Roosevelt Lofts – Historic Rehabilitation & New Apartments – 22-3281

ADDENDUM NO. 1

**AREA B
THIRD FLOOR PLAN**
1/4"=1'-0"

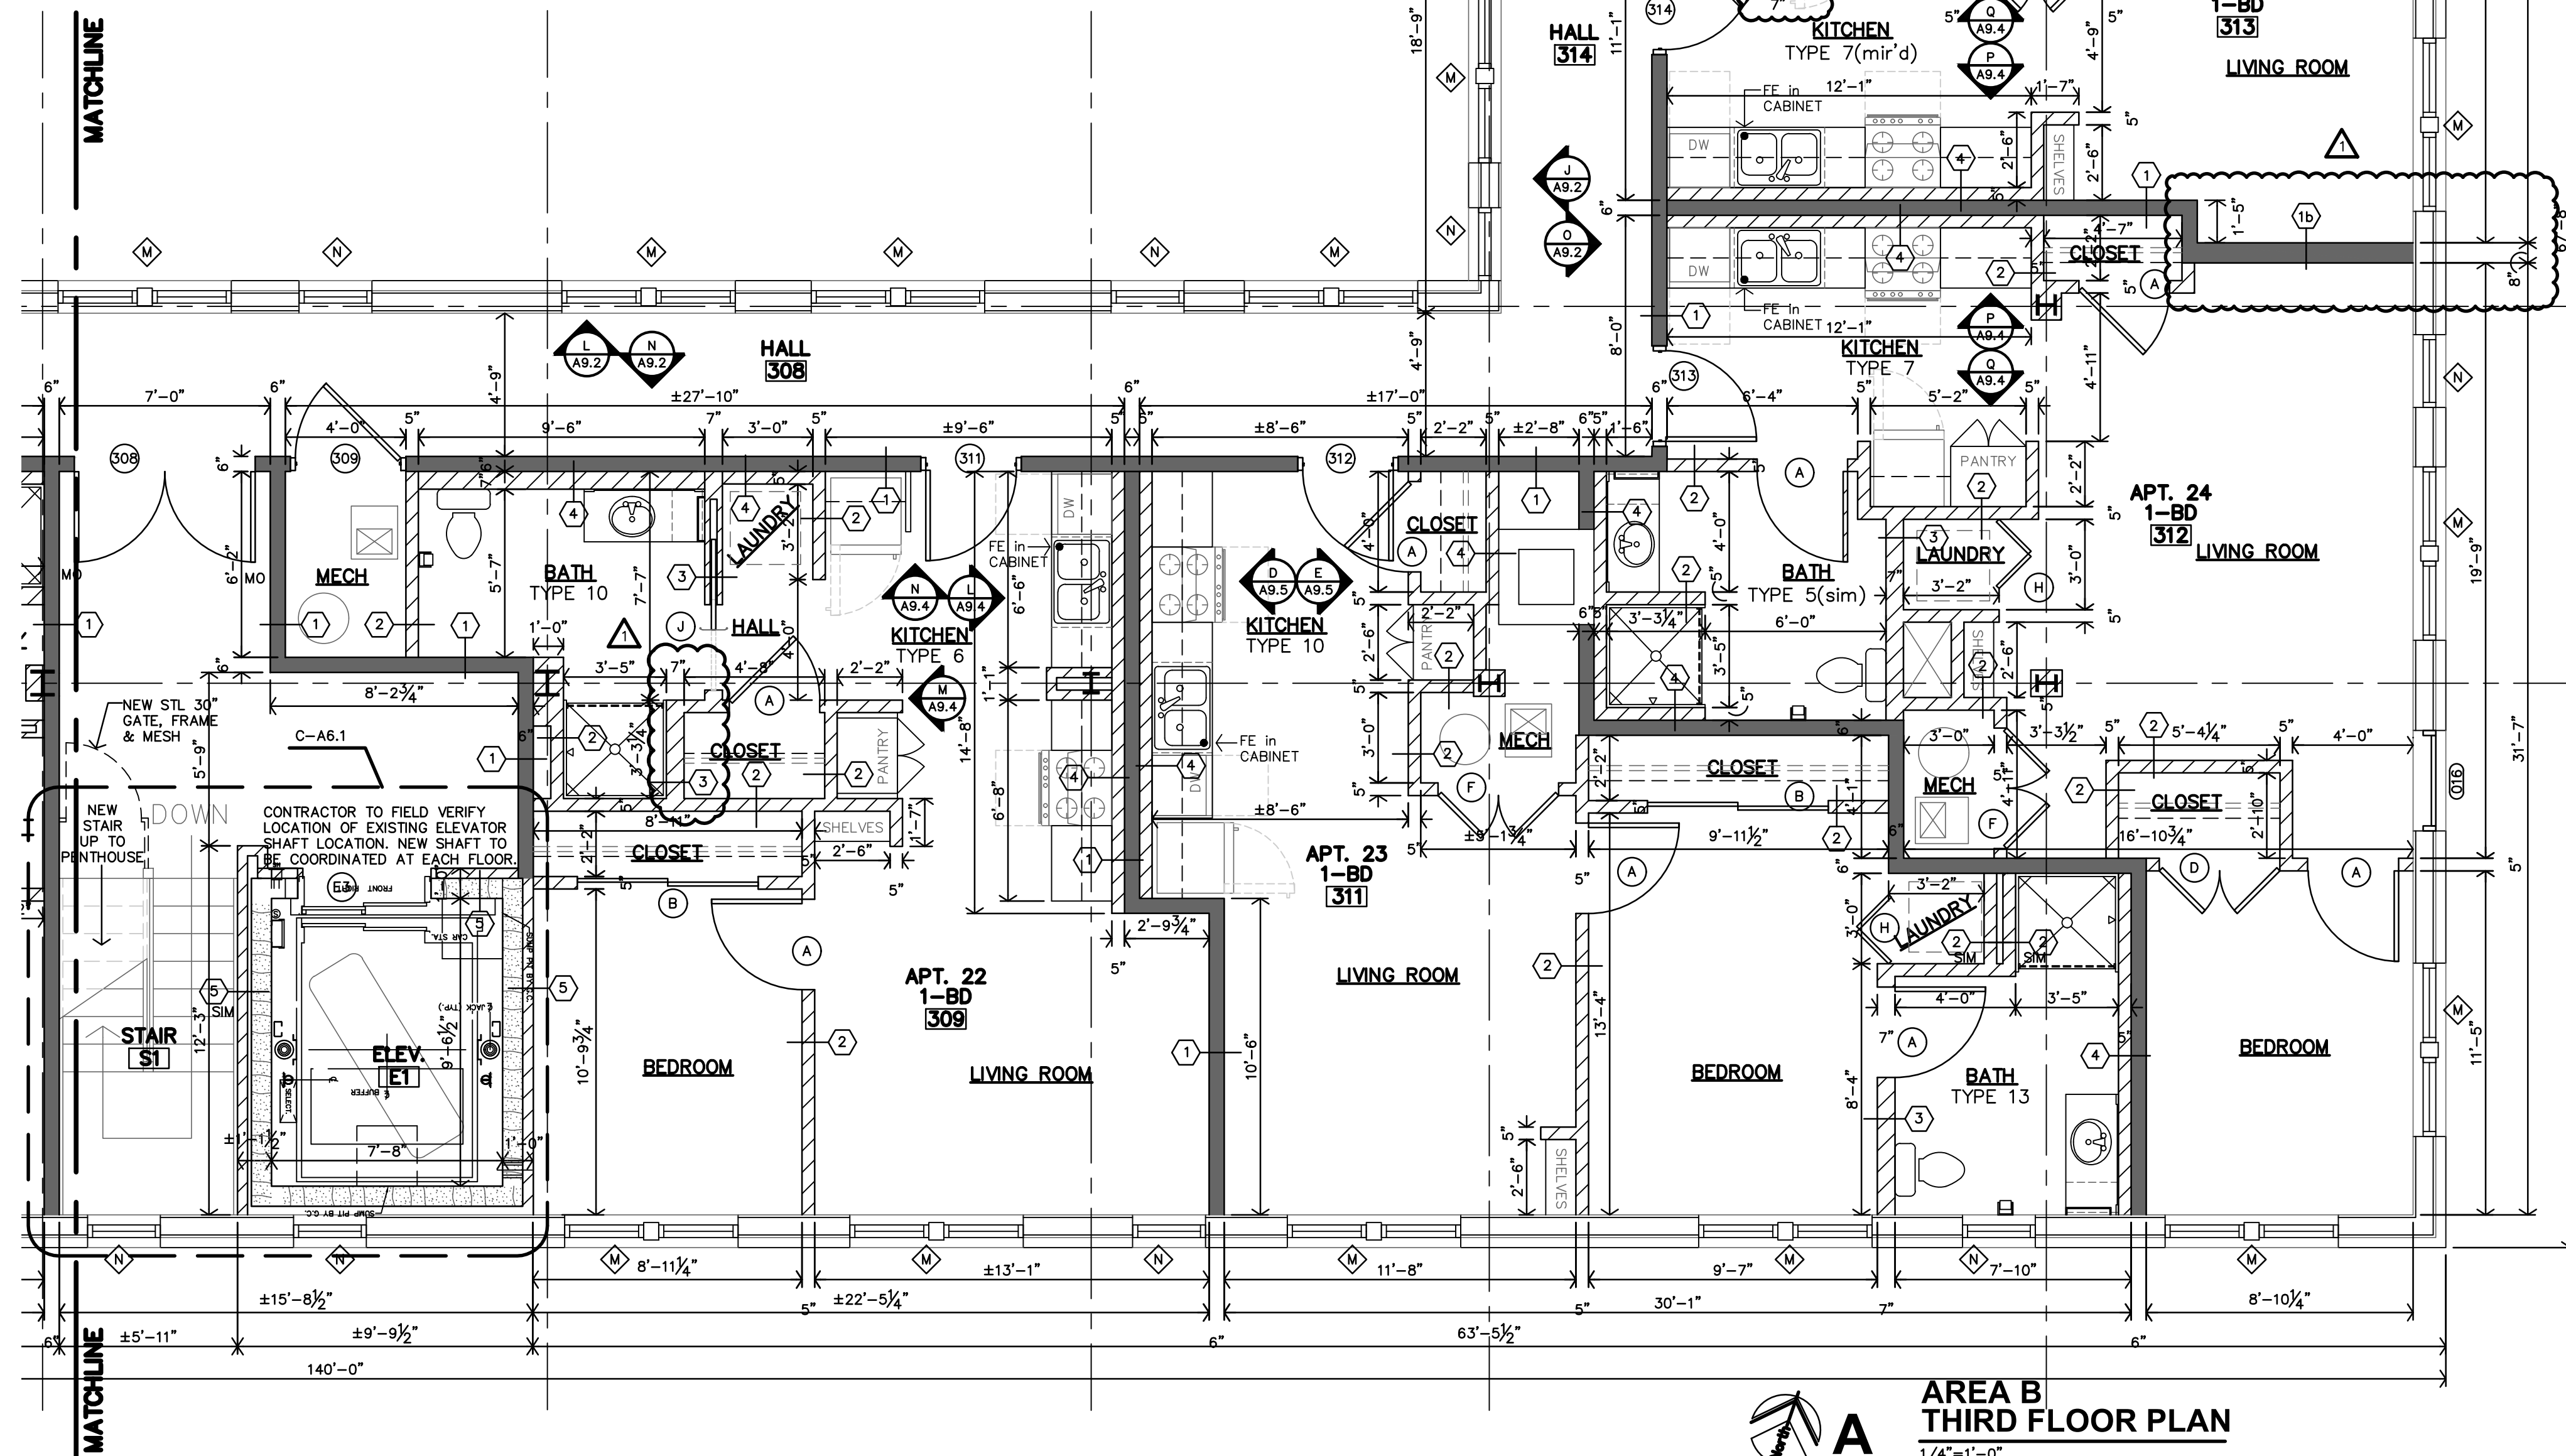
- b. Add wall Type 1B
5. Sheets A2.3 – A2.8 – Several places where walls have been thickened to a 2x6 stud vs. a 2x4 to allow for plumbing and vent ducts to route up through them.

- a. Unit 112 – wall behind Laundry has been changed to a Type 3
 - b. Unit 113 – wall in-between Laundry and Mech has been changed to a Type 3
 - c. Unit 114 – wall in-between Laundry and shower has been changed to a Type 3

- d. Unit 122 – wall behind Laundry has been changed to be 7" thick vs. 5" thick.
 - e. Unit 123 – wall behind Laundry has been changed to be 7" thick vs. 5" thick

- f. Unit 127 – wall behind Laundry has been changed to be 7" thick vs. 5" thick
 - g. Unit 201 – wall in-between Laundry and Shower has been changed to a Type 3

- h. Unit 202 – wall behind Laundry has been changed to a Type 3
 - i. Unit 203 – wall in-between Laundry and Mech has been changed to a Type 3
 - j. Unit 207 – wall in-between Laundry and Shower has been changed to a Type 3

- k. Unit 212 – portion of wall in-between Units 212 & 213 has been changed to a Type 1B

- l. Unit 213 – wall in-between closet and refrigerator has been changed to a Type 3
 - m. Unit 301 – wall in-between shower and laundry has been changed to a Type 3

- s. Unit 313 – wall in-between closet and refrigerator has been changed to a Type 3. Wall in-between shower and vanity has been changed to a Type 3.
6. Sheet A3.1

REMOVING GRAFFITI FROM HISTORIC MASONRY

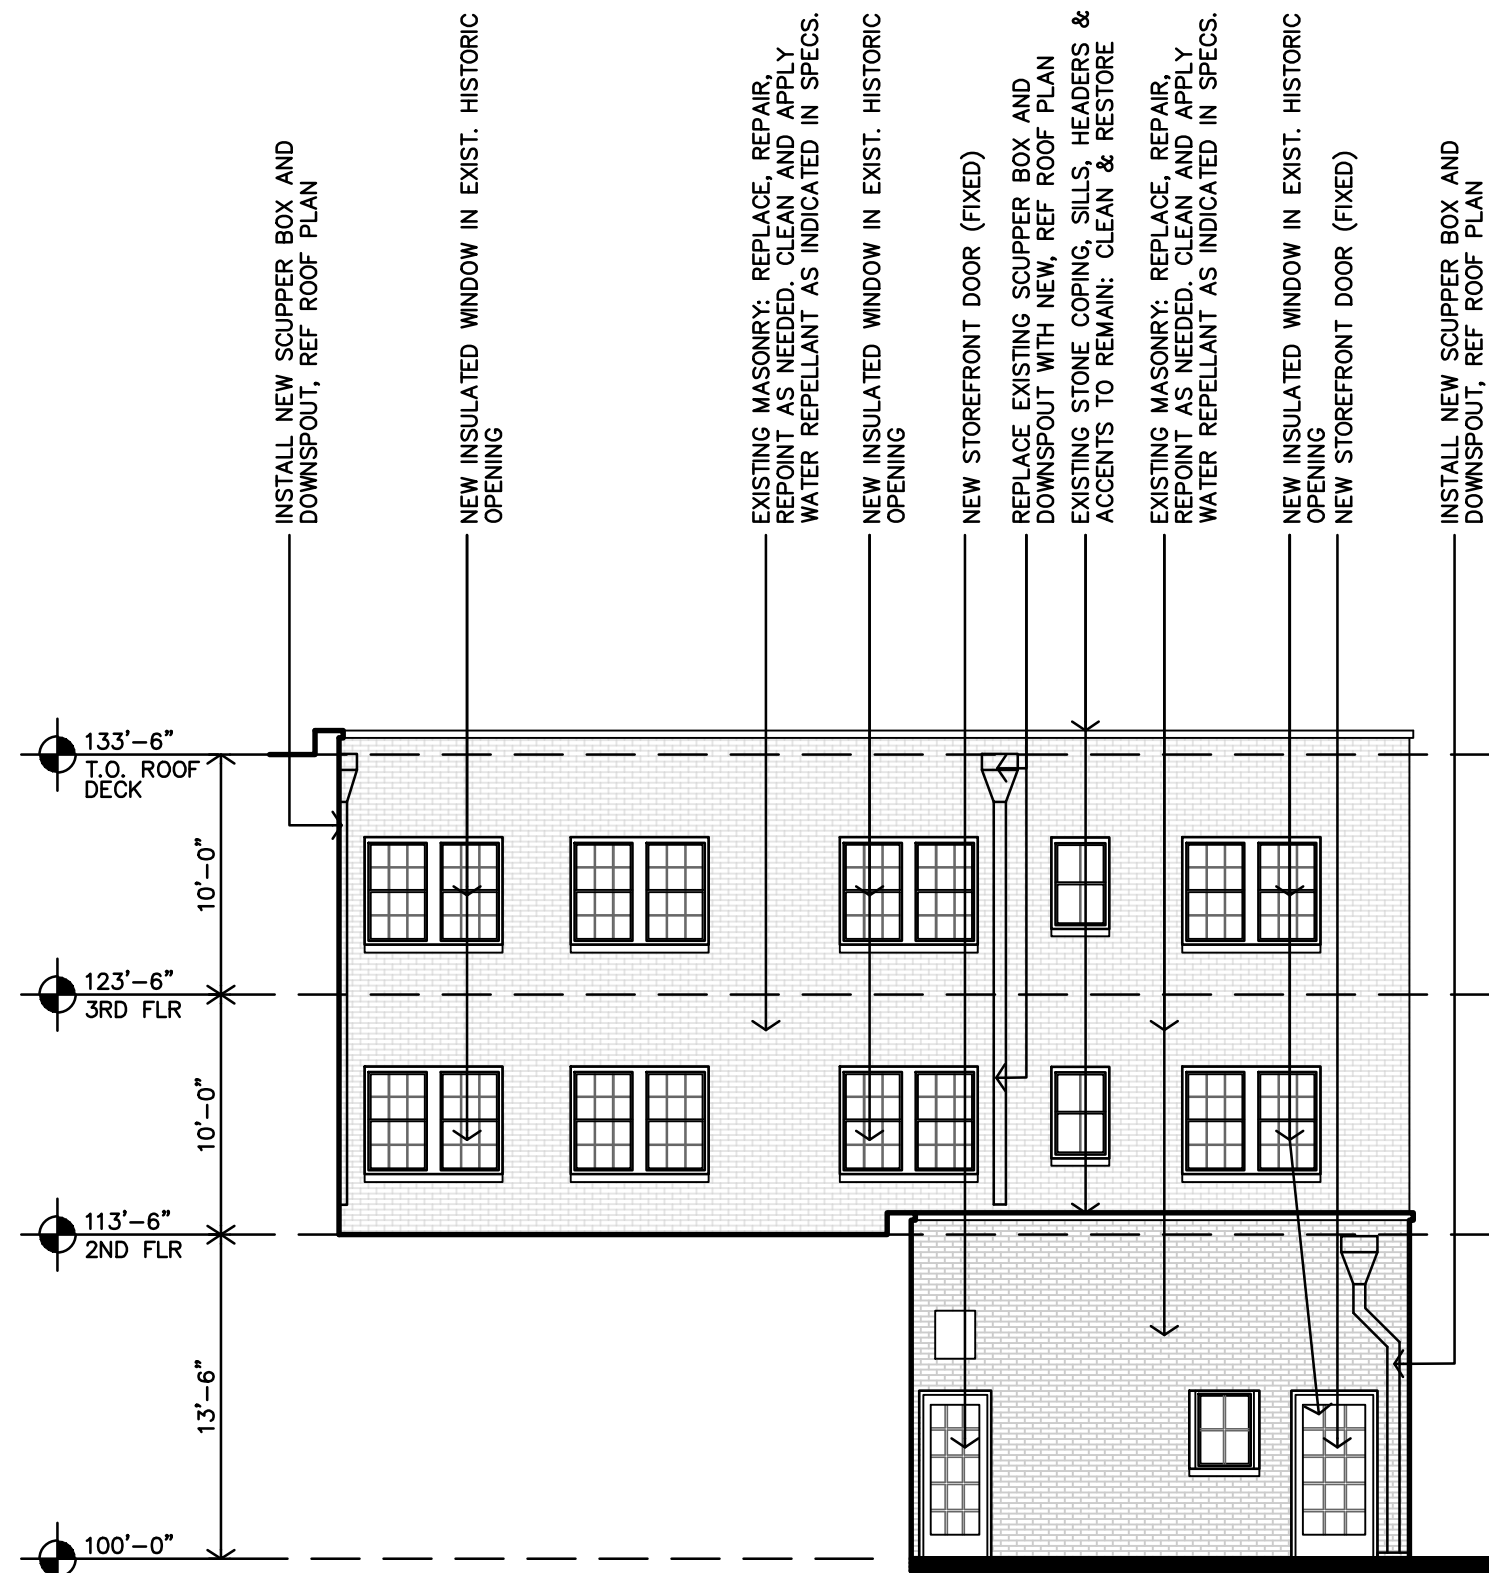
7. Sheet A3.2 – “Remove Graffiti from Historic Masonry” Notes have been added.
8. Sheet A8.3
- a. Detail B – Note (Type B Unit) has been added to the label. 30x48 side approach has been added in front of the sink. Remove notation ‘6’ at vanity.

C
TYPE 3 - ADAPTABLE (TYPE B UNIT)
ENLARGED BATH PLAN
3/8"=1'-0"
APT 3 (#113)
SIMILAR: APT. 11 (#202), APT. 19 (#302)

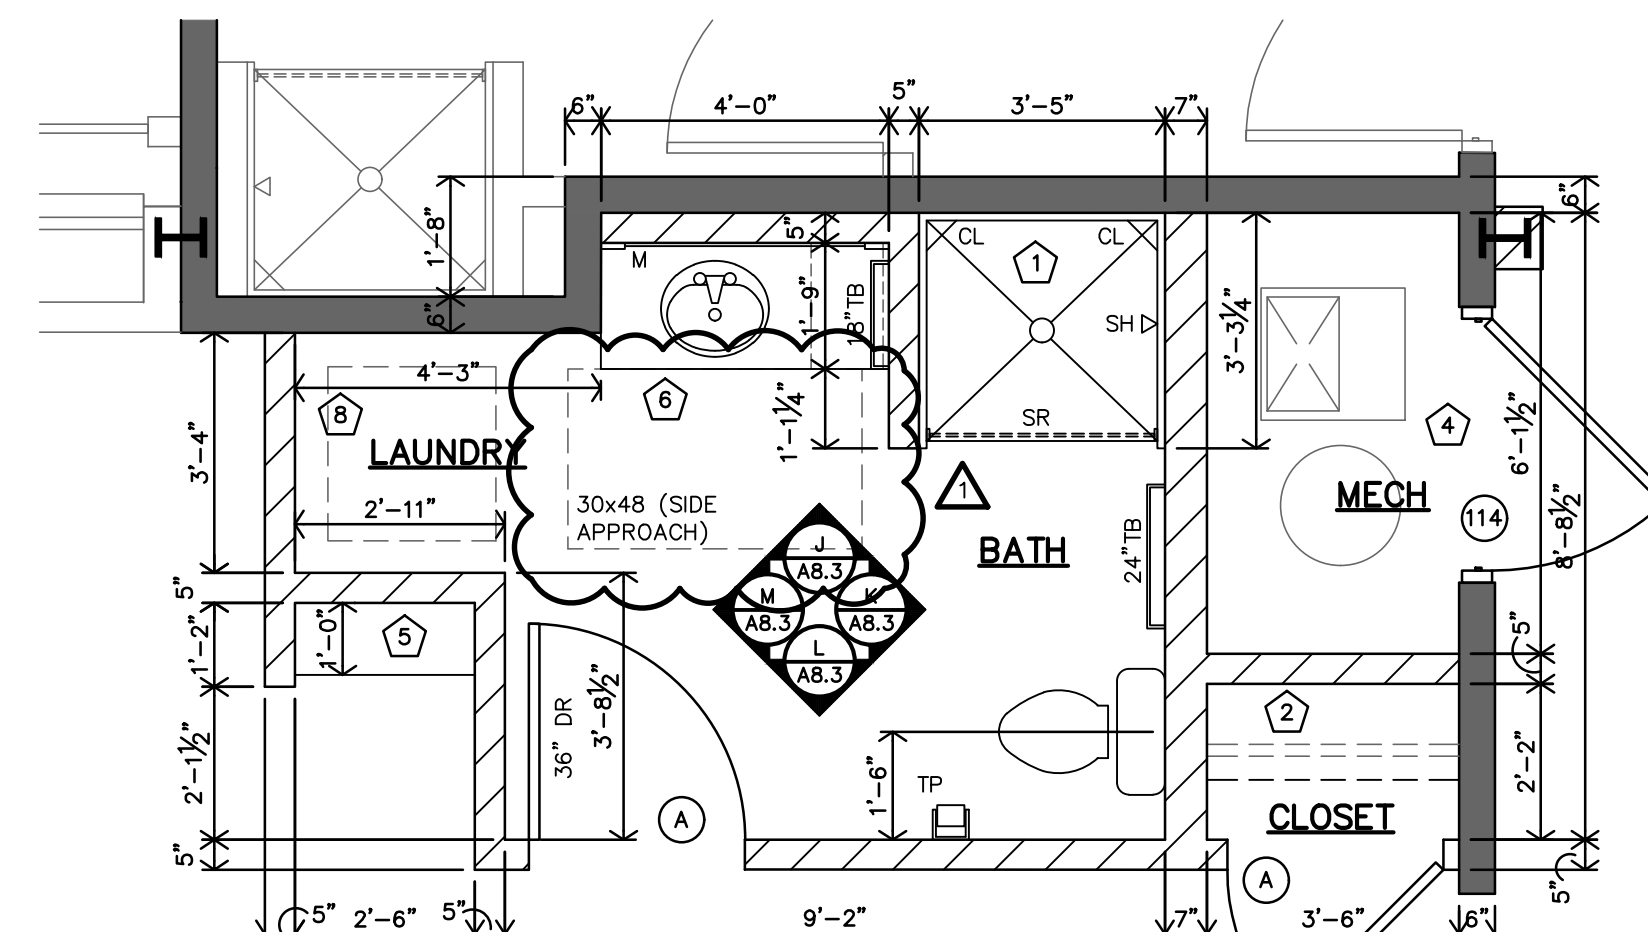
- b. Detail C – Note (Type B Unit) has been added to the label. 30x48 side approach has been added in front of the sink. Remove notation ‘6’ at vanity.

J ACCESSIBLE KITCHEN CASEWORK SECTION
3/4"=1'-0"

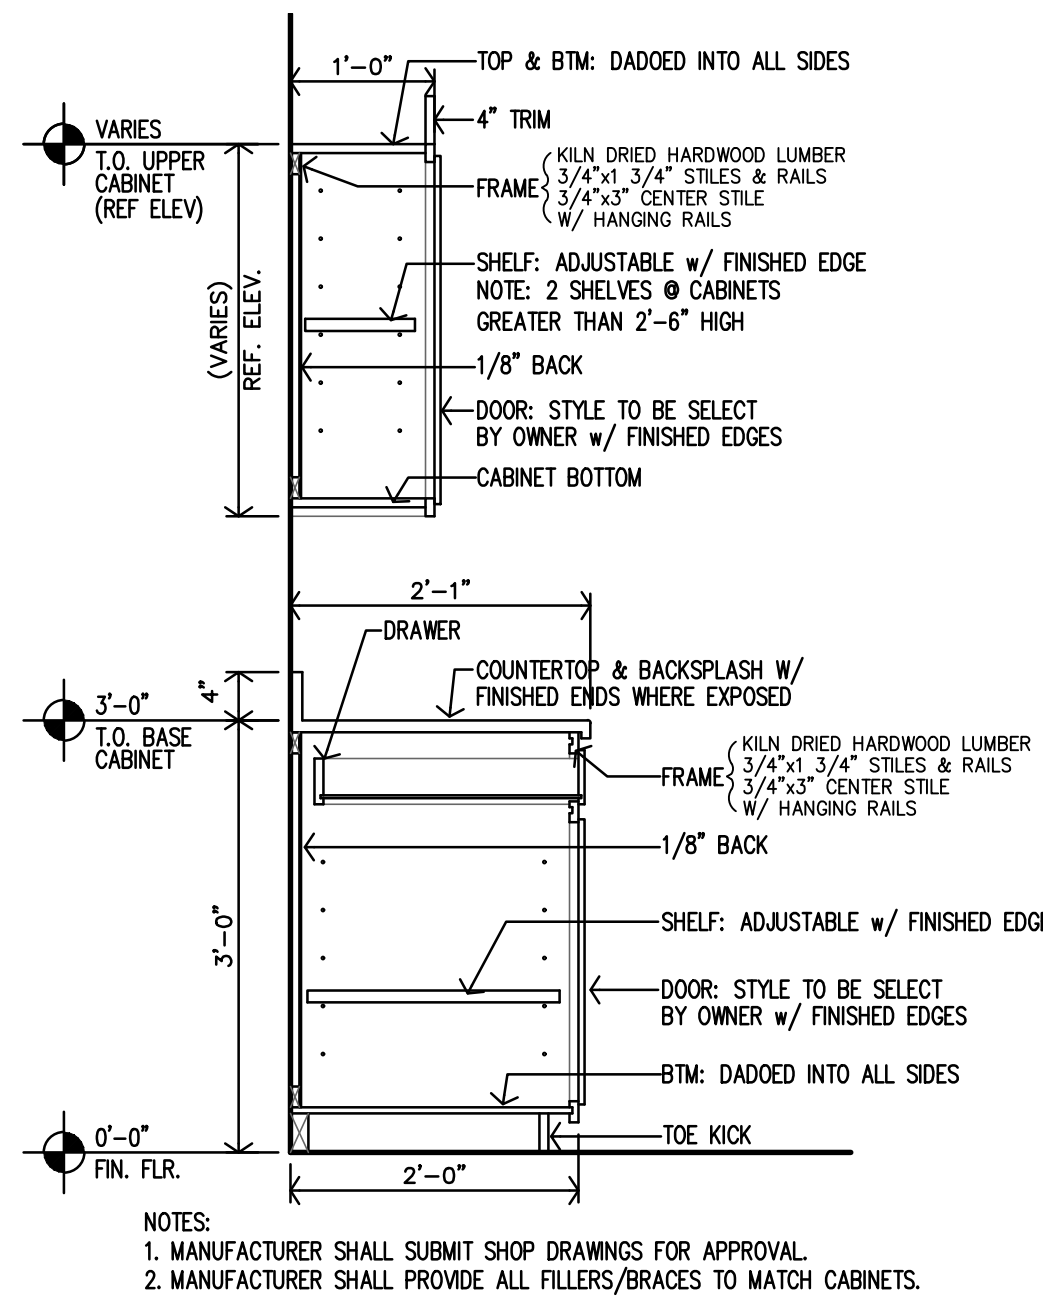
- d. Detail E – “Removable Cabinet” note has been removed.
 - e. Detail J – “Removable Cabinet” note has been removed. This shall be an open ADA compliant cabinet with knee space below.
